## Environmental Planning Commission

Agenda Number: 6  
Project #: 2020-003658  
SI-2020-00356

### 2<sup>nd</sup> Supplemental Staff Report

| <b>Request</b>           | 1) Major Amendment to Site Plan –EPC                                      |

Figure 1: Continuous View Plan

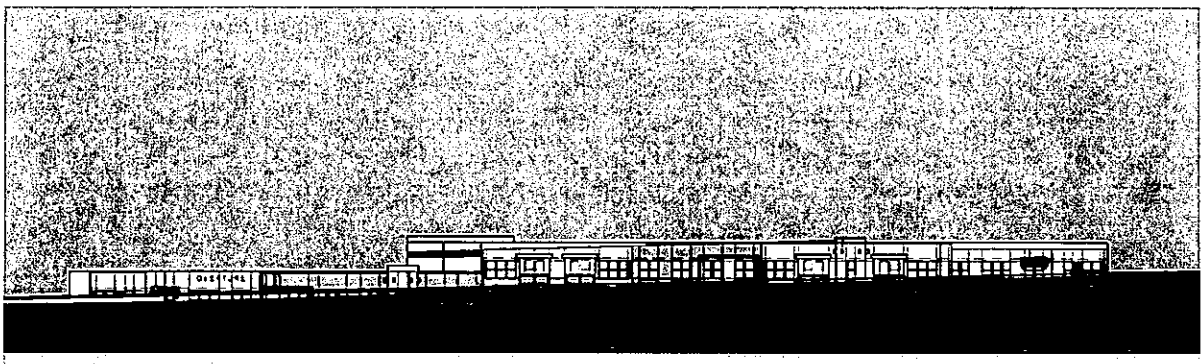
*The applicant has submitted a revised design which removes the third story from the building along Coors Blvd. at the lower elevations. The lower building height places most of the building in compliance with the view plane analysis. A portion still remains more than 1/3 above the plane ranging from 2'4" down to 0 over a 75' distance.*

*On the eastern side of the building the degree of non-compliance is slightly higher ranging from 5'-3' down to 0 over 100'. This portion, being further from Coors would have less impact than the west part of the building.*

*Staff has interpreted this View Plane to be a sloping plane since the right driving lane of Coors is sloping. The ZEO has confirmed the appropriateness of this method in his determination.*

*Using this interpretation, the image above shows the 4-foot (minimum) elevation above Coors in red (the purple shows a straight slope from highest to lowest elevation). Carrying that plane horizontally the yellow portion is in excess of the 1/3 height allowed.*

3. Building should be reduced by either the extent to which the height is over the View Plane by more than 1/3 of the building height or by removal of the third floor in those area.

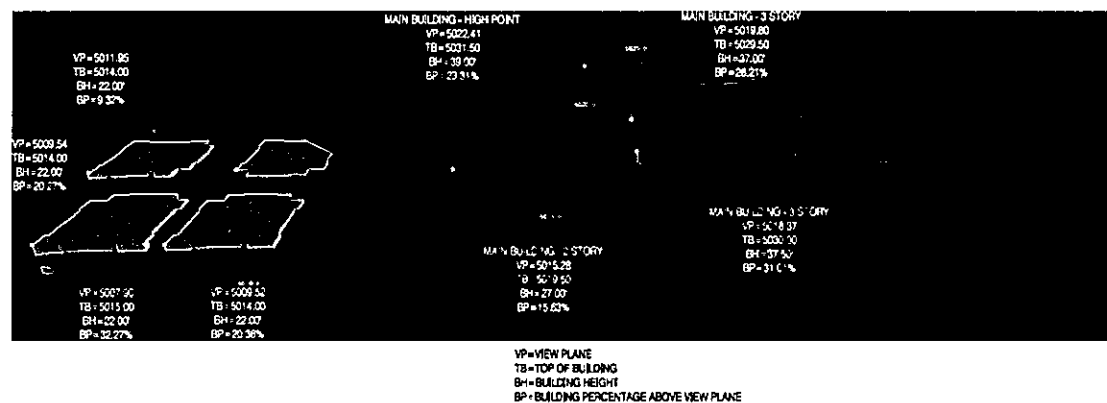
*The applicant has provided a view plane going across the site at a 45-degree angle. Under this analysis, the entire building is in compliance.*

VIEW FRAME AREA: 20.8162  
BLOCKED AREA: 7.0716 (33.97%)  
VIEW FRAME AT SIGHT LINE A1

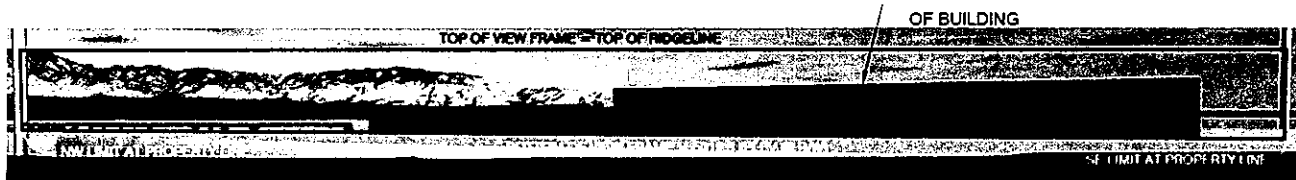
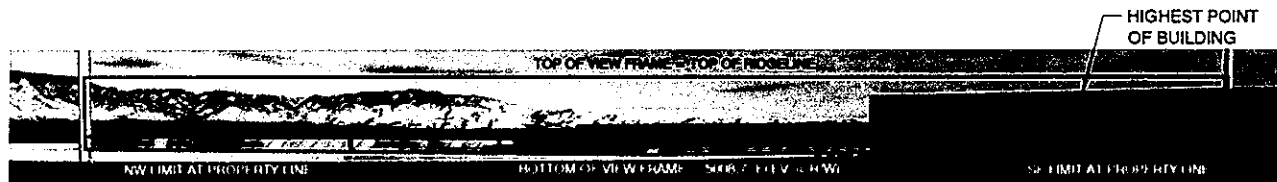
*The applicant has submitted additional sightlines and view frames for additional points on the main building originating lower on Coors as well as view frames taken through the smaller cottages at the northern end of the site.*

*The View Frame should result in a slice of the building at the frame location. The View Frame provided by the applicant show the building with a tapering roof line as in perspective. This should not be the case. The building height should be at a straight height.*

*All view frames of the revised design fall within the View Frame parameters of less than 50% blockage of the frame.*

Consensus Planning used a flat VIEW PLANE that was:

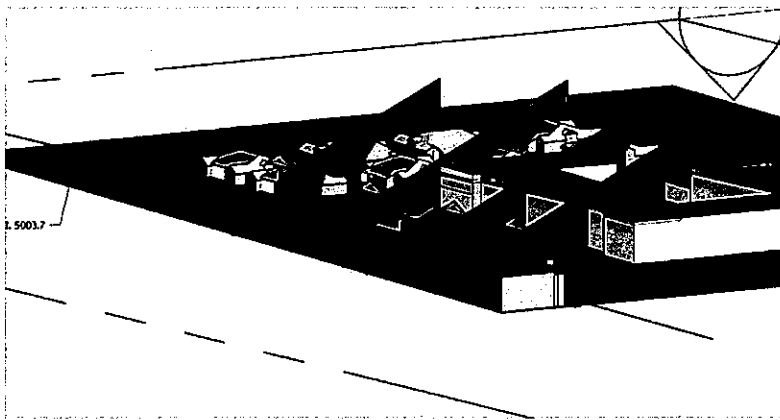
- 4 feet above Coors and horizontal to Coors at 90 degrees at the southern end of the site;
- 14 feet above Coors and vertical to Coors at 90 degrees at the northern end of Coors.

Each interpretation had a different outcome with that of Consensus Planning being completely compliant and those of Pat Gallagher and staff showing varying degrees of non-compliance. Based on the above analysis and holding true to the definition of a VIEW PLANE as written in the IDO, the VIEW PLANE shall be defined as:

***One continuous plane, originating at 4 feet above the right driving lane of Coors Blvd from all elevations and continuing across the site at a 90-degree angle. Building heights shall not penetrate this plane by more than 1/3 of the building's height.***

Pat Gallagher utilized four different VIEW PLANES that were:

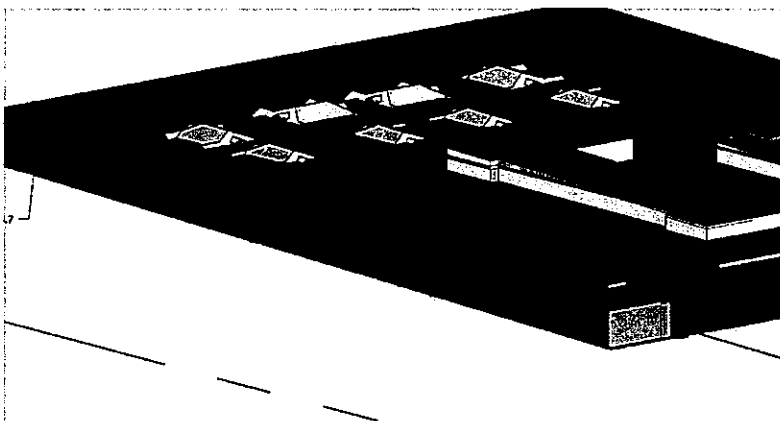
- 4 feet above the right lane of Coors
- At 45 degrees to Coors
- Vertical to Coors
